Calallen ISD

Subject: Consider approval of change order #1 for CHS Pool Facility

**SUBJECT: SUPPLEMENT NO. 1 (Revision 1)
GEOTECHNICAL RECOMMENDATIONS
CALALLEN INDEPENDENT SCHOOL DISTRICT
CALALLEN HIGH SCHOOL
MULTI-PURPOSE BUILDING NEW POOL ADDITION
4105 Wildcat Drive
Corpus Christi, Texas
RETL Job No. – G117269**

CONTRACT CHANGE ORDER #1

S104 POOL SECTION SCALE 3/16" = 1'-0"

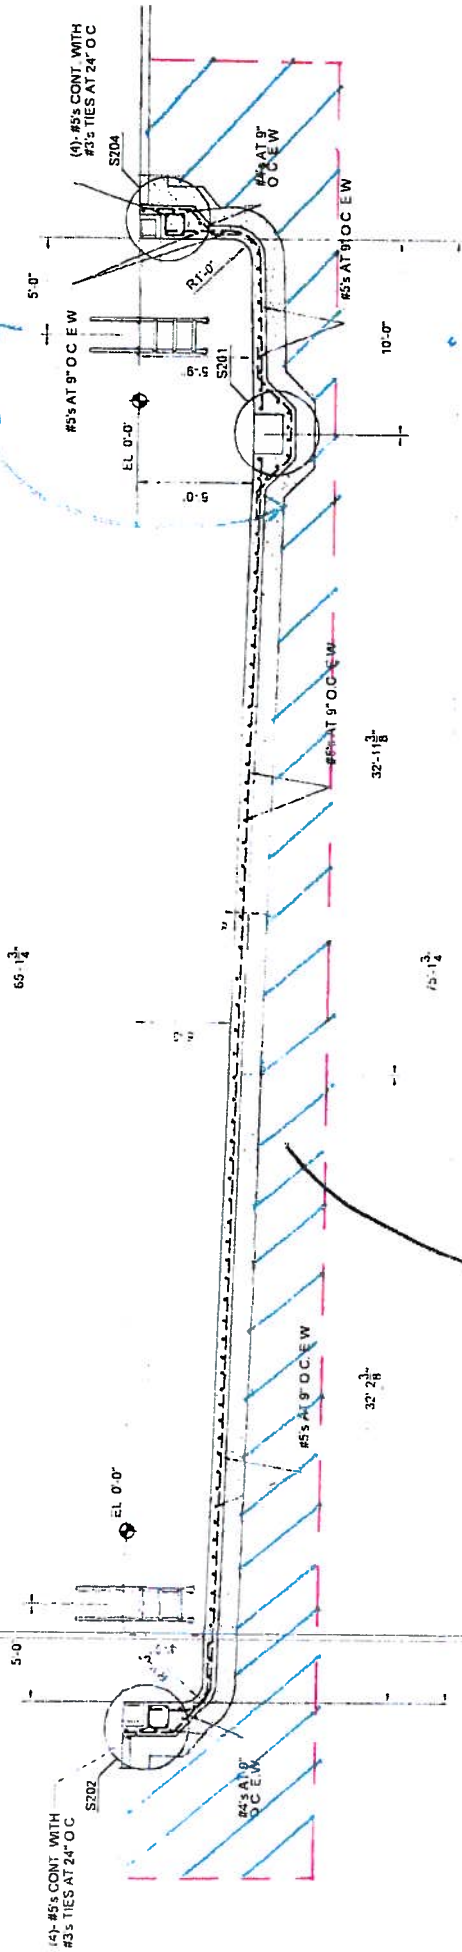
AREAS OF SELECT FILL

Provide revised earthwork specifications according to Rock Engineering & Testing Supplement No. 1 (Revision 1) dated 4/18/17. Pricing to include excavation of subgrade and placement of required quantities of select fill to achieve a 1" PVR . Provide epoxy coated reinforcing steel for concrete pool shell.

In order to reduce the PVR to approximately 1-inch, sitework improvements will include removing the existing soils from an elevation of 82.5-feet to an elevation of 76.5-feet, or 6-feet, moisture condition and compact the exposed subgrade soils, and finally place a minimum of 7-feet of properly compacted non-expansive "Select Fill" soils in order to achieve a finished floor slab elevation of 83.86-feet.

In order to reduce the PVR to approximately 1-inch, sitework improvement will include removing the existing soils from beneath the bottom of the swimming pool bearing elevation a minimum of 3½-feet, moisture condition and compact the exposed subgrade soils and finally place a minimum of 3½-feet of properly compacted non-expansive **"Select Fill"** soils.

Provide removal of subgrade and placement of 7' of select fill under slab on grade and 3.5' of select fill under pool. Select fill to be placed in 8" lifts and compacted to 95%. Placement and compaction of select fill to be monitored by Rock Engineering. The depth of fill placement will achieve a 1" Potential Vertical Rise (PVR).
